LOUISIANA
POWER & LIGHT

Subject: Waterford SES Unit 3
Docket No. 50-382
Technical Specification Change Request NPF-38-83

DESCRIPTION AND SAFETY ANALYSIS
OF PROPOSED CHANGE NPF-38-83

FIGURE 1

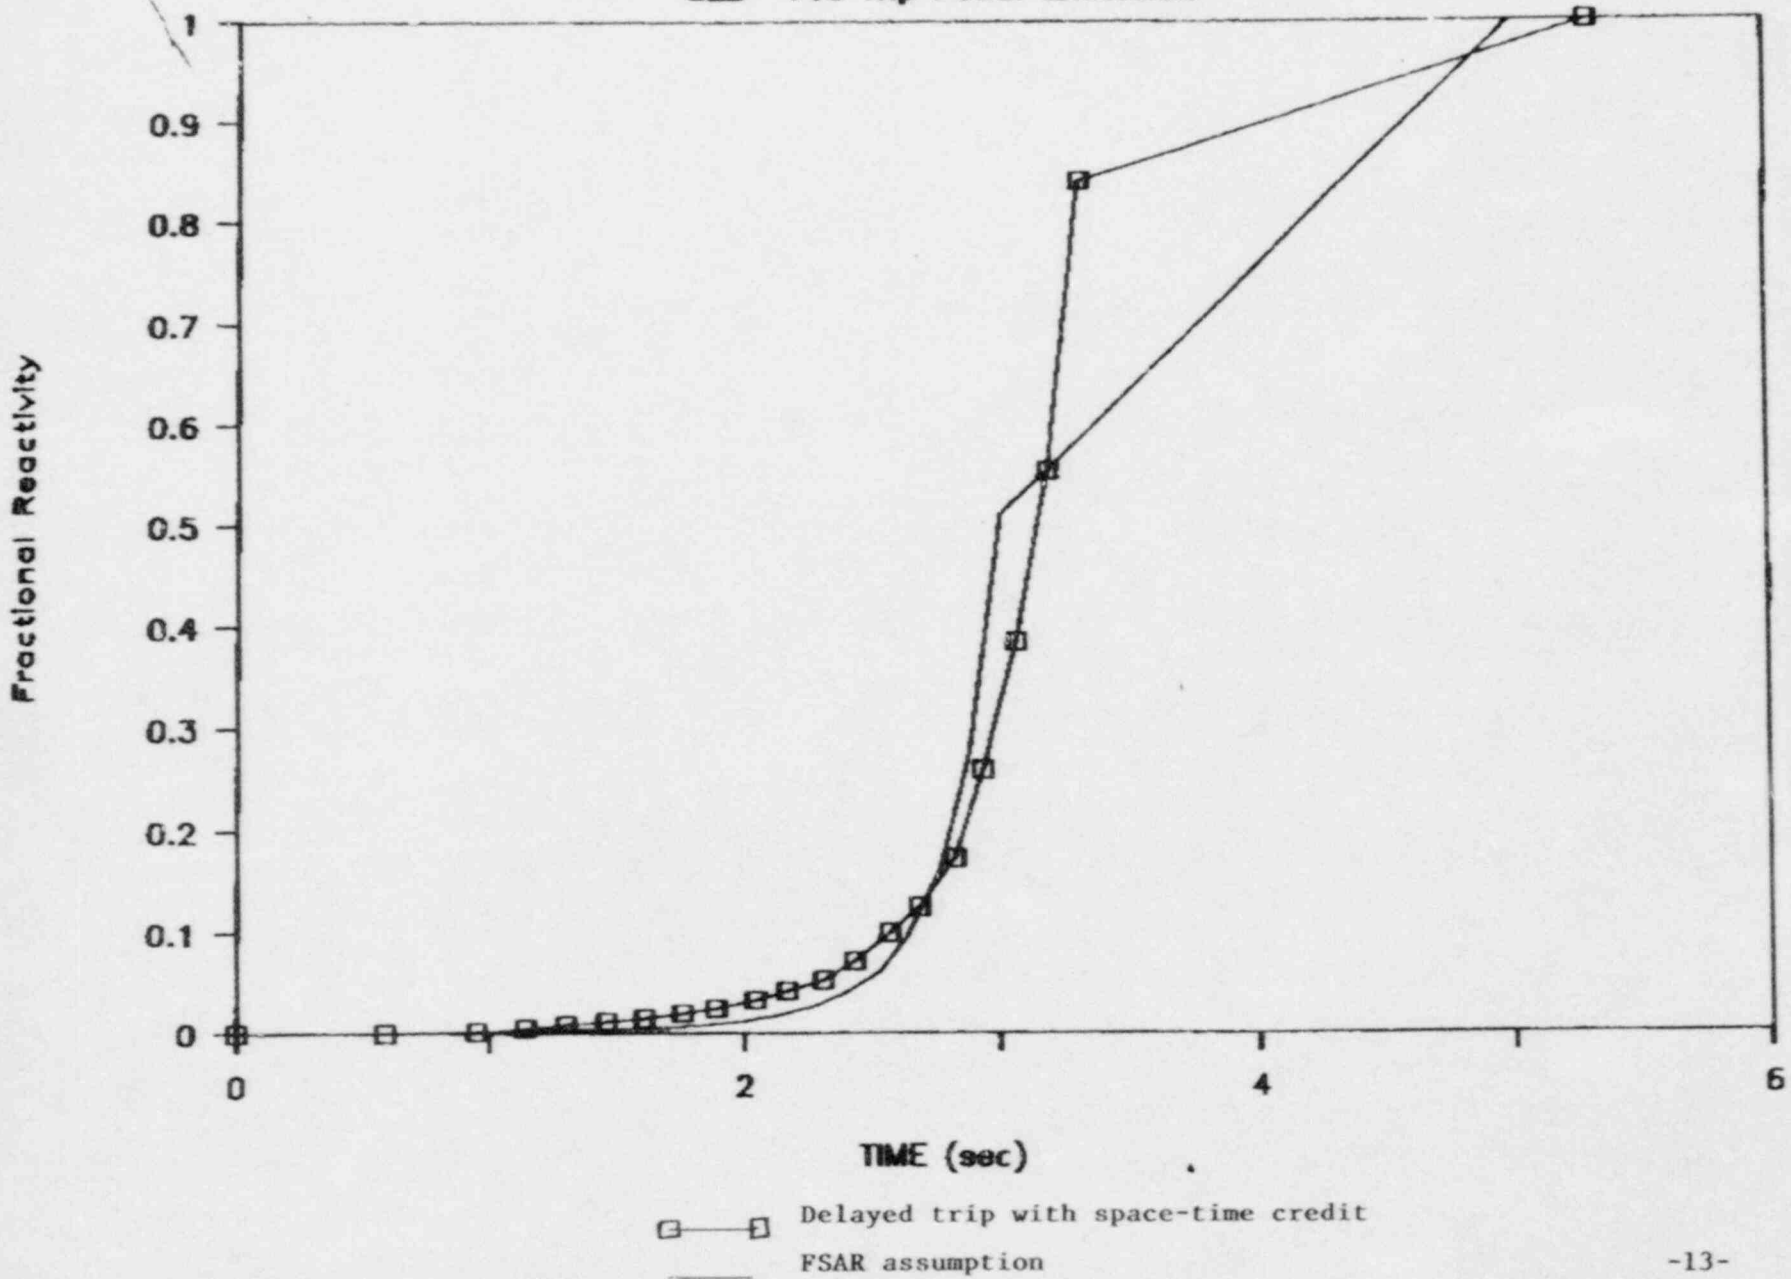
The results of this event were last reported in support of Cycle 2. In terms of radiological consequences, the limiting Pre-trip power excursion was the outside containment break location. The time of minimum DNBR was 1.9 seconds after the trip breakers open. The transient was modelled using static scram curves. Figure 1 shows a comparison of the negative reactivity added by the static scram curve used and a space time scram curve with CEA motion delayed by 0.3 seconds. A slight non-conservatism exists prior to 1.0 seconds, but never exceeding $0.005\% \Delta \rho$. By 1.15 seconds the space time curve is conservative and at the time of minimum DNBR, the delayed space time curve added $.075\% \Delta \rho$ more negative reactivity than the static curve inserted. Near full insertion the revised curve again predicts less negative reactivity insertion but this is well past the point of minimum DNBR. Therefore, the conclusions of this event are unchanged.
